Notice of Modification

Application Number: 06_0191

Project: Orica Southlands Remediation & Warehouse Development Project

SRD DA016 (J)

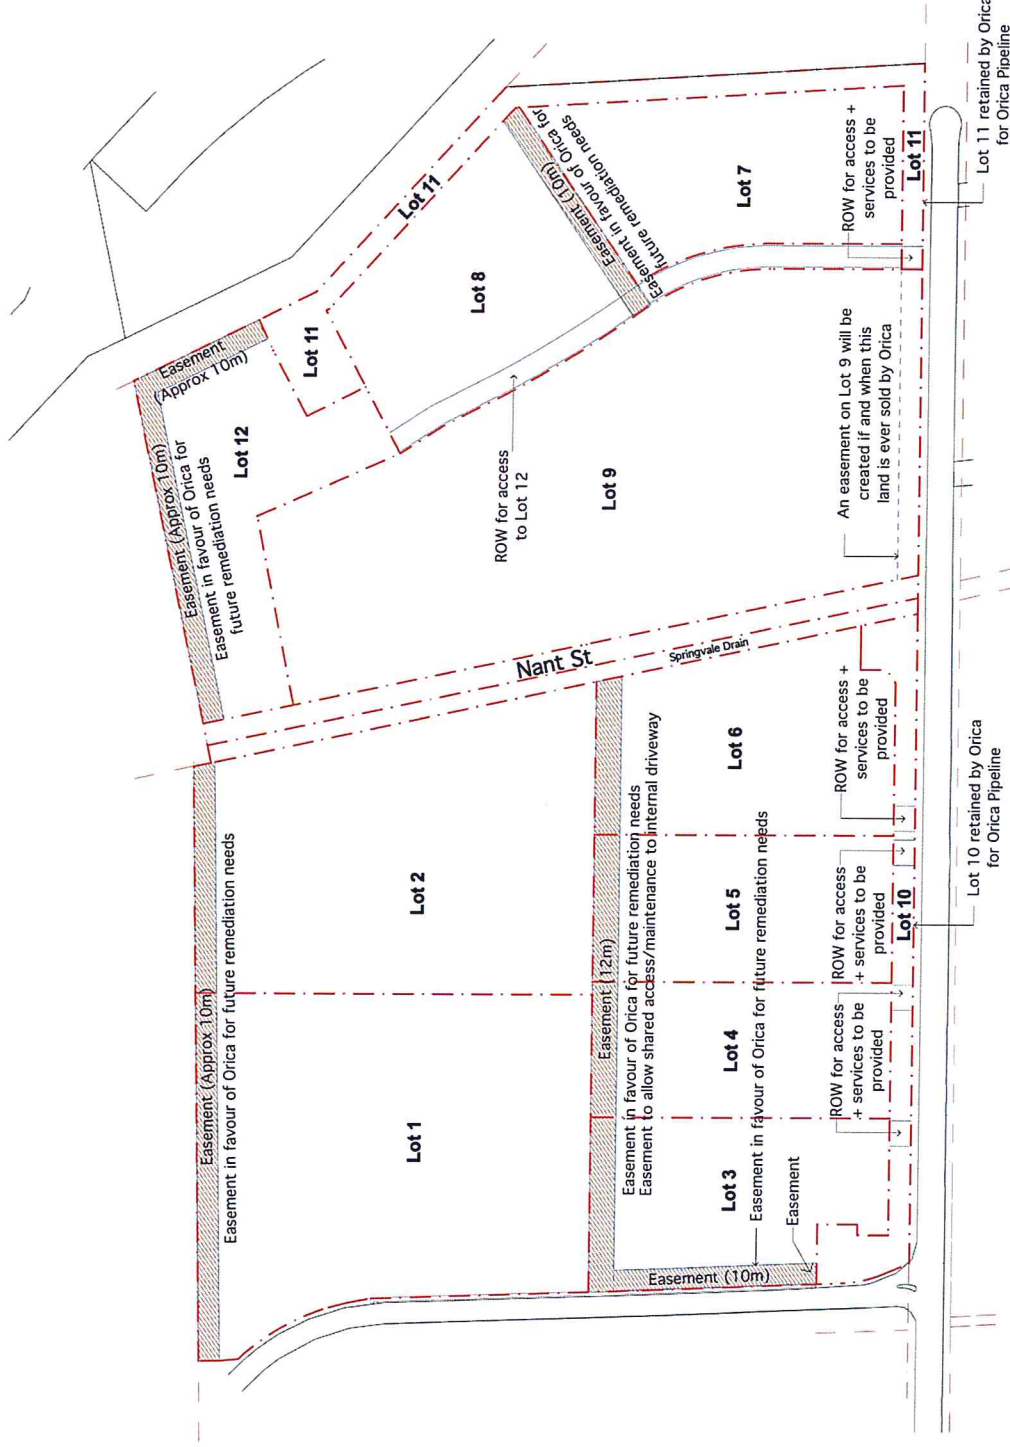
- Subdivision (and easements) Subdivision of only Lots 1 DP 254392, Lot 1 1078077, Lot 1 DP 85542 and Lot 11 DP 109505 into Lots 1-12 in accordance with the subdivision plan SRD DA016(J) and SRD DA017 J) at APPENDIX 5

8. Replacing Condition 13 of Schedule 2 with the following:
13. The Proponent shall carry out the subdivision of the land north of McPherson in accordance with the subdivision plan SRD DA016(J) at Appendix 5 of this approval.

SRD DA0.17 (H)

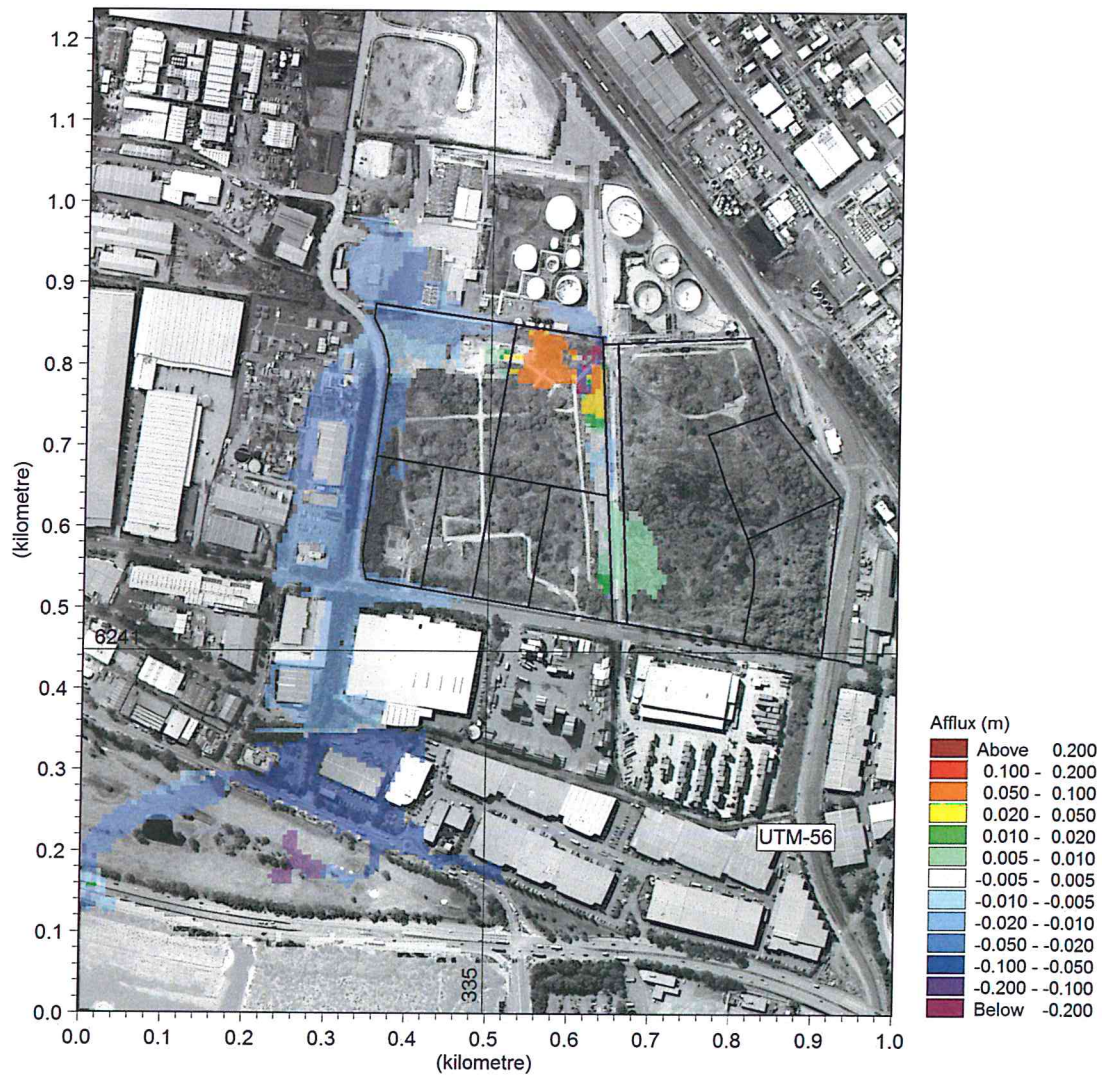
15. Easements for services, drainage, maintenance or any other encumbrances and indemnities required for joint or reciprocal use of part or all of the proposed lots as a consequence of the subdivision, must:
 - a) be created over those lots pursuant to the *Conveyancing Act, 1919*;
 - b) be in accordance with the easement plan SRD DA017 (H) at Appendix 5 of this approval; and
 - c) be to the satisfaction of Council or the Principal Certifying Authority.

16. The Proponent shall maintain sufficient access rights to the infrastructure identified in the Easements Plan SRD DA017(H) for the duration of the BGCuP to allow for all activities related to the approved VMP or other regulatory instrument and potential future remediation works. The Proponent shall advise both the Department and the EPA of any changes to the Easement Plan.

Southlands Industrial Estate **Figure D9a**
Final Development Scenario 50% AEP flood level difference map

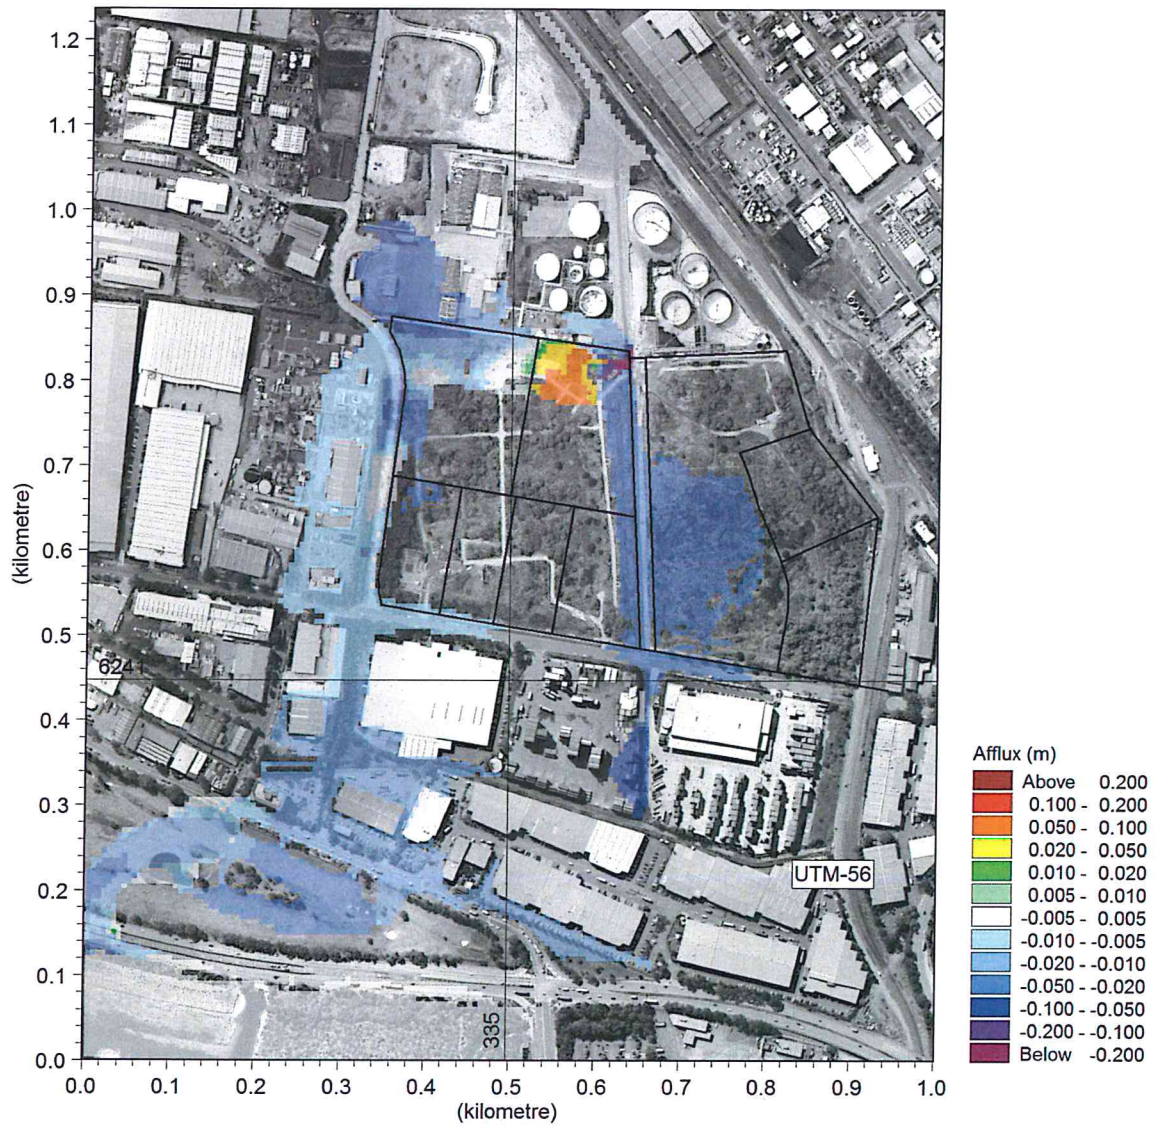
15. Replacing Condition 10 of Schedule 3 with the following:
 10. The Proponent shall commission and pay the full cost of a Hydraulic Modelling Flood Validation Assessment Report to confirm that the 'as constructed' Stage 1 compensatory flood storage works have been undertaken in accordance with the principles outlined in Orica Southlands Remediation and Development Project Hydraulic Modelling Report and Response to Exhibition Submissions/Comments – (Report Ref: 204617, 29th November 2010, Revision 3 by Aurecon) as amended by the addendum letter report titled Southlands – Detailed Design 2D Flood Re-Modelling – Addendum Advice Regarding Variation to Compensatory Flood Basin Design and Impact (Prepared by Aurecon, dated 22 February 2013), and that the flood impact is no greater than indicated in Figures D9a, D10a and D11a of the addendum report (Appendix 6). The assessment must:

- d) provide easy to read figures indicating any differences between the results provided on Figures D9a, D10a and D11a of the Aurecon 2013 addendum report;

- f) recommend and prioritise measures to be undertaken in the event that the assessment shows that the flood impact exceeds that shown on Figures D9a, D10a and D11a of the Aurecon 2013 addendum report and that the works as executed are not in accordance with this approval.
